STAFF RECOMMENDATION

1410 Boscobel Street

January 20, 2016

Application: New construction – outbuilding; Detached accessory dwelling unit
District: Lockeland Springs-East End Neighborhood Conservation Zoning Overlay
Council District: 06
Map and Parcel Number: 08313034300
Applicant: Craig Kennedy, Architect
Project Lead: Sean Alexander, sean.alexander@nashville.gov

SITE PLAN

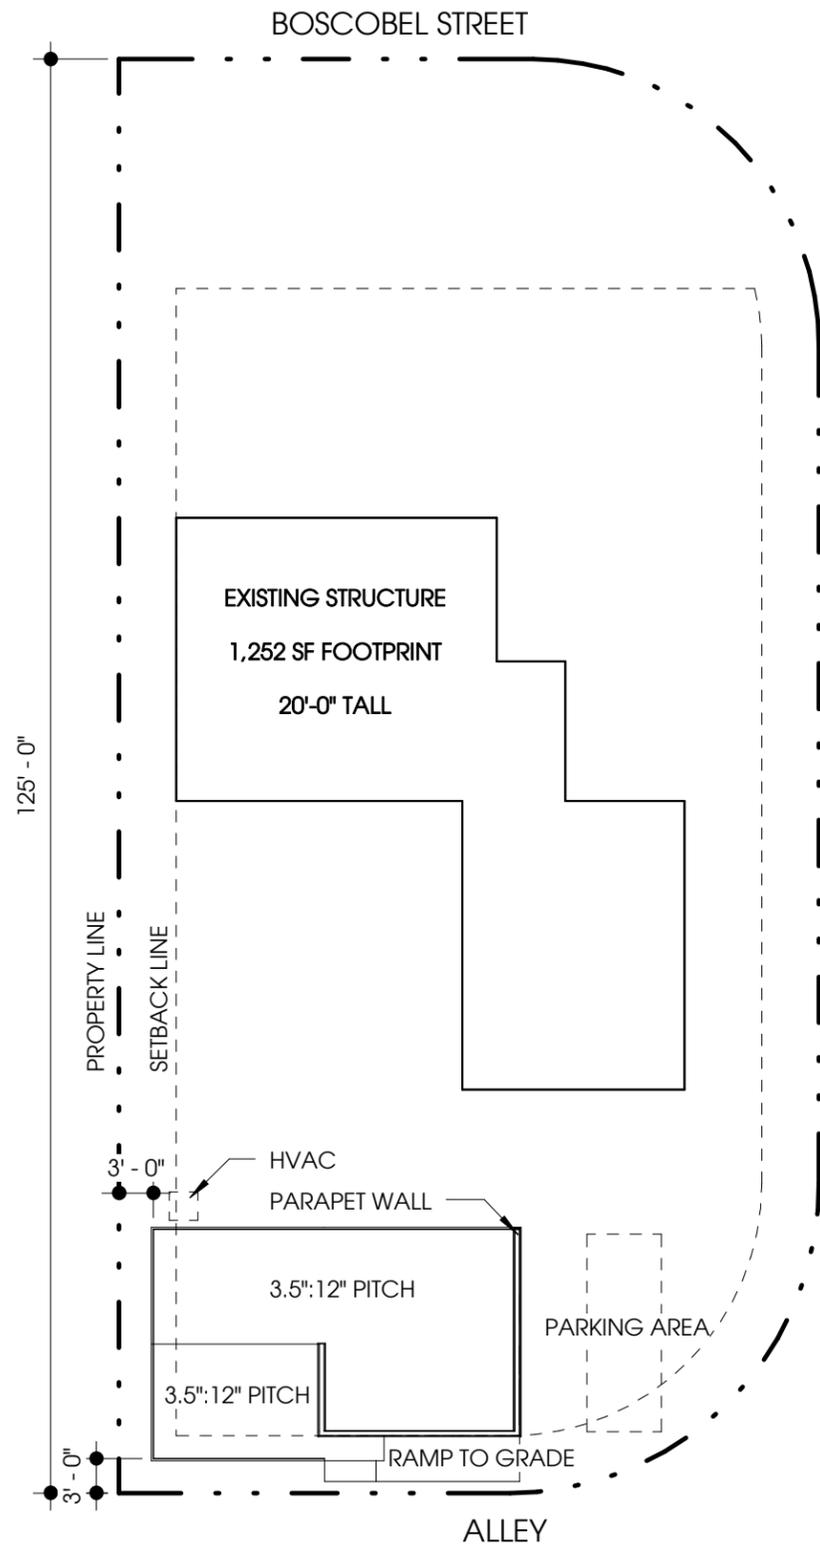
The outbuilding will have a footprint of six hundred, five square feet (605 sf). The entire building will be used as living space, without a garage component. The outbuilding meets all base zoning setbacks, and will have an eave height of nine feet (9’) and a ridge height of fifteen feet, four inches (15’-4”), which is subordinate to the historic house. The proposed materials have all been approved by the Commission in the past, and include smooth-faced cement-fiberboard lap siding with a reveal of five inches, cement-fiber panel siding, and cement fiberboard trim. The roof will be asphalt shingles and the foundation will be a concrete slab on grade.

1. Under section 17.16.030.f.1.b of the Metro Code, Detached Accessory Dwelling Units are allowed when there are no other accessory buildings greater than two hundred square feet (200 sf) on the lot. There is currently a two hundred, sixty square foot (260 sf) carport at the front of the lot. This structure will be demolished, which will meet the applicable standards.
2. The design guidelines require twenty feet (20’) of separation between the principal building and the accessory building. The proposed outbuilding will be located twelve

feet (12') from the principal building. Staff finds this location appropriate because the lot at 1410 Boscobel is only one hundred, twenty-five feet (125') deep, nearly twenty-five feet (25') shallower than most lots in the surrounding area.

- Staff shall approve the final details, dimensions and materials of windows and doors prior to purchase and installation;
- The existing carport shall be demolished; and
- Staff shall receive a restrictive covenant for the detached accessory dwelling unit.
